**STATE OF TENNESSEE  
DEPARTMENT OF TRANSPORTATION  
DESIGN DIVISION**

**INSTRUCTIONAL BULLETIN NO. 13-08**

**Regarding New and Revised Standard Drawings**

**Effective for the July 12<sup>th</sup> letting (May 1<sup>st</sup> turn-in),** the following Standard Drawings are new or revised and Section V of the Design Guidelines is revised for this update.

**TYPICAL PLAN VIEW OF MULTI-LANE ROUNDABOUT**  
SEE GENERAL NOTE K

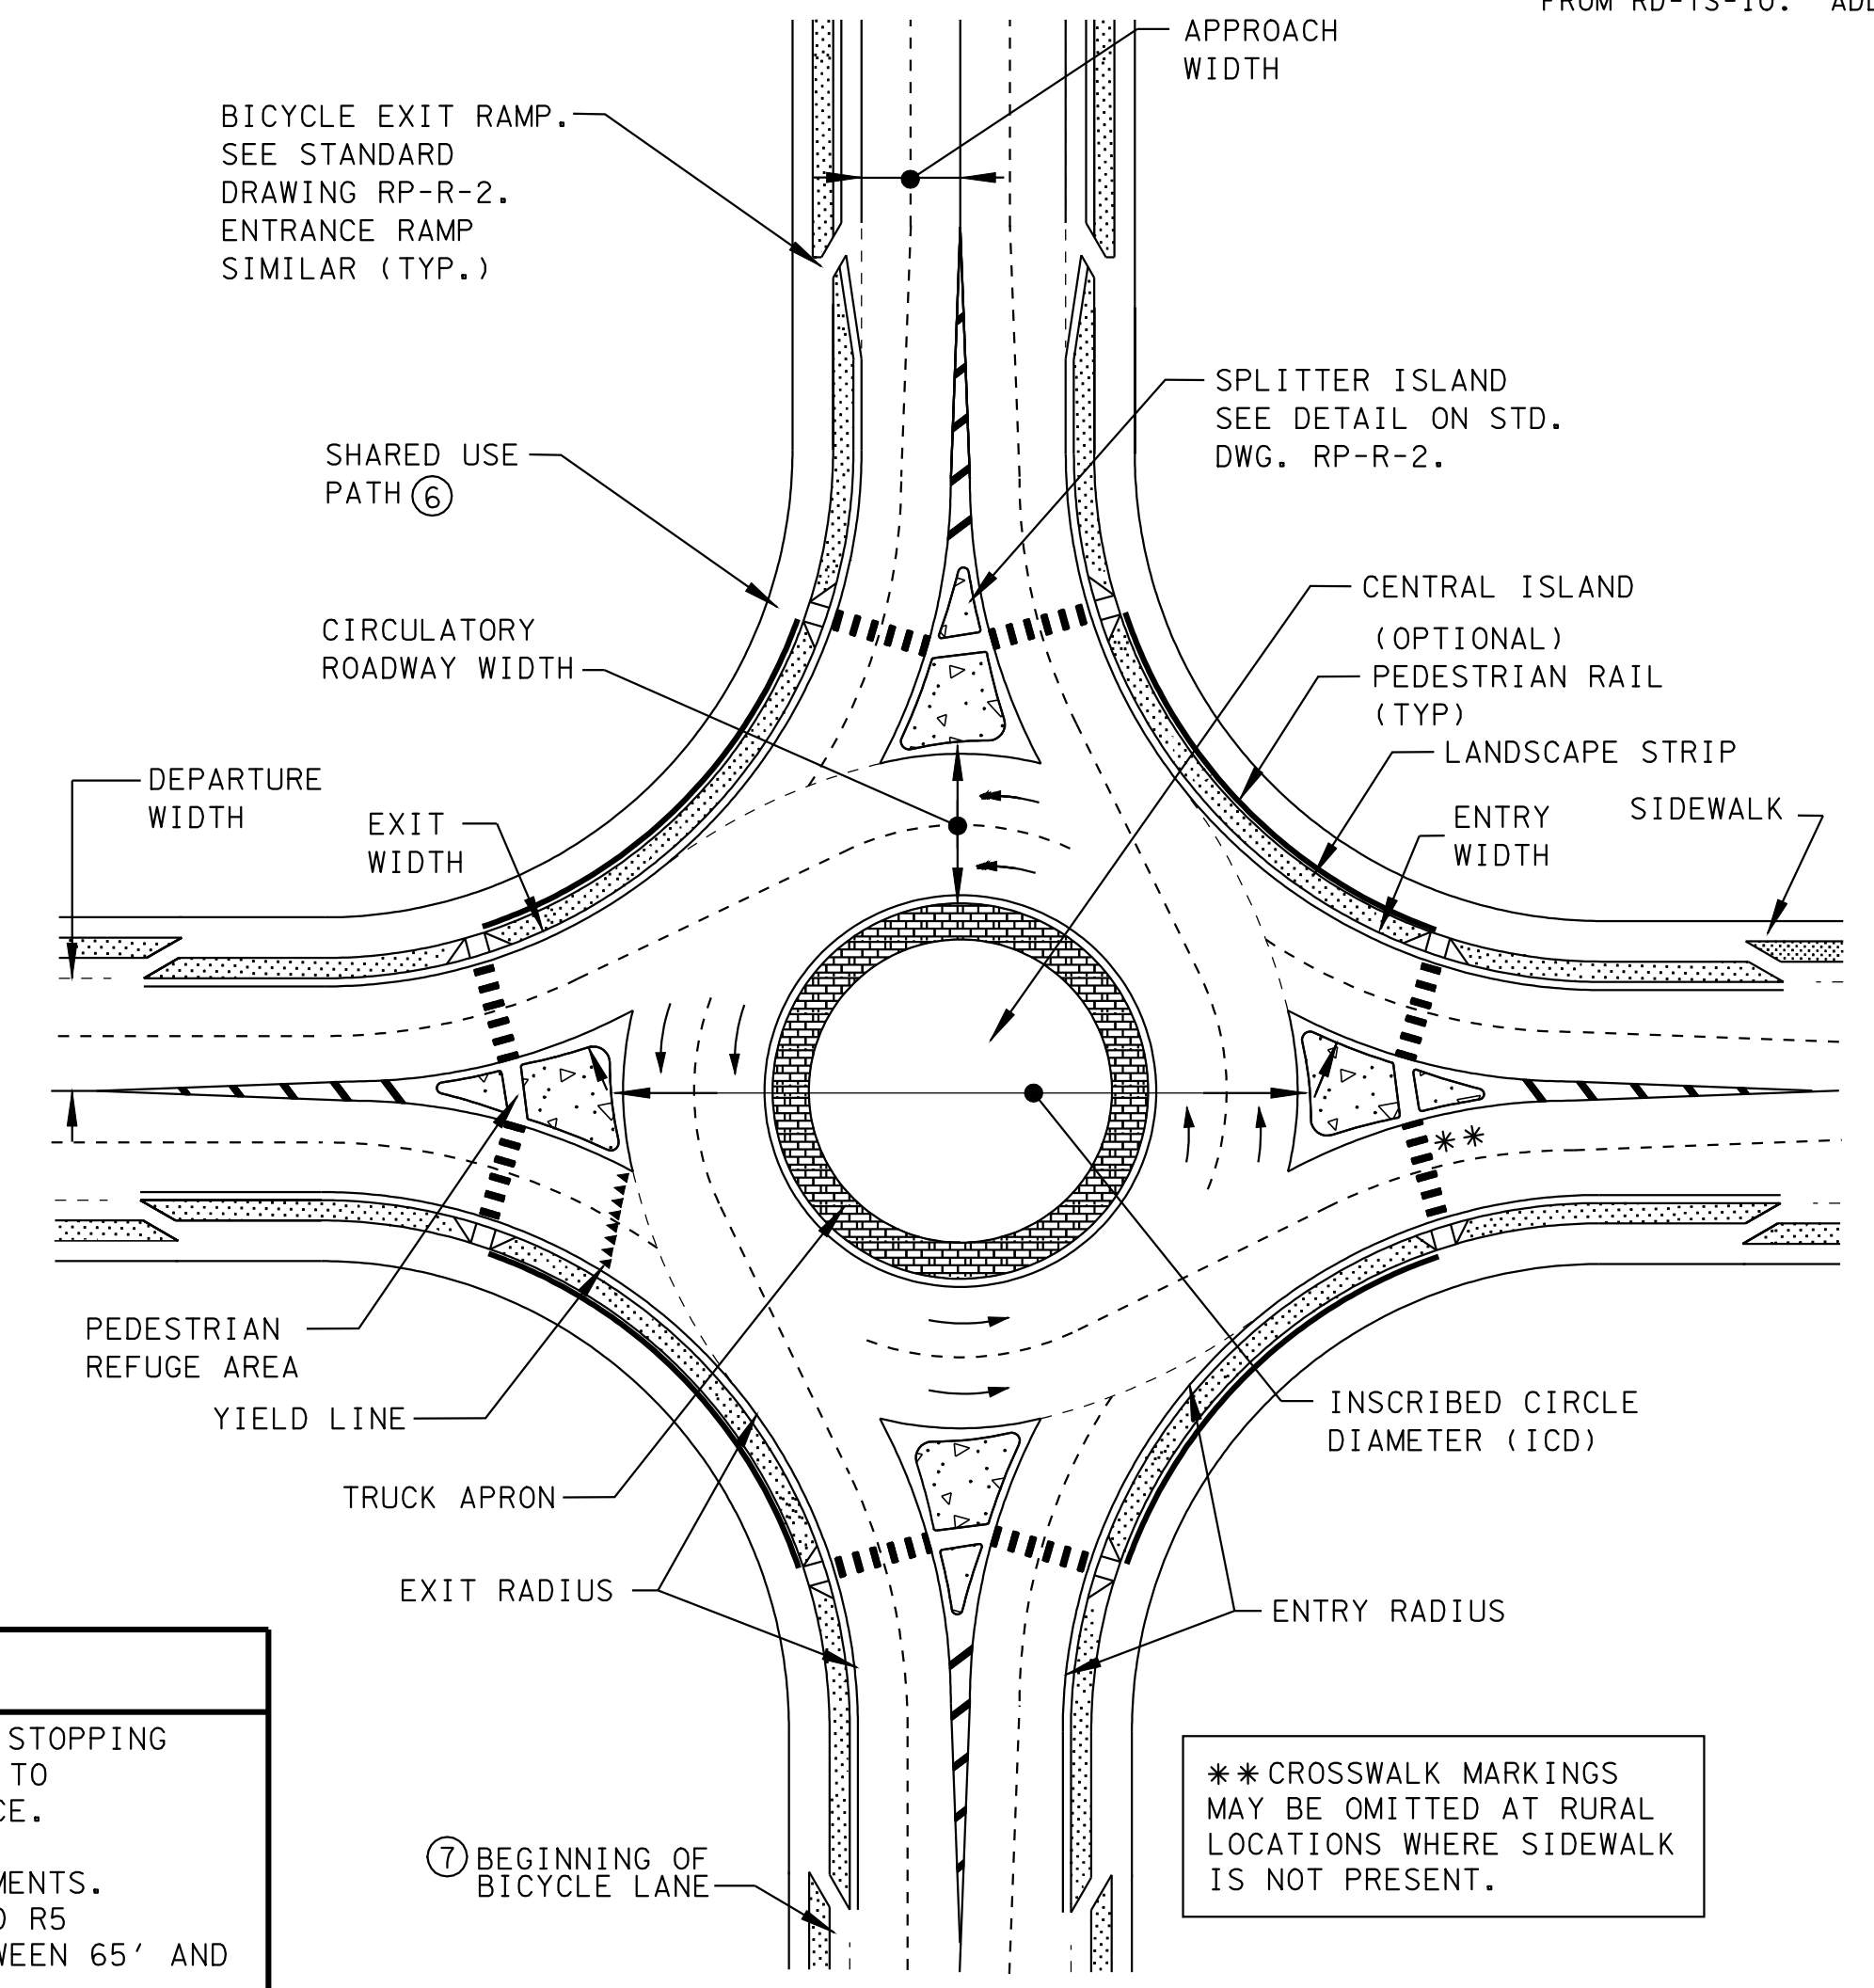
REV. 2-1-12: ADDED OPTIONAL PEDESTRIAN RAIL.  
 REV. 6-15-12: RENAMED SHEET FROM RD-TS-10. ADDED NOTE (M)
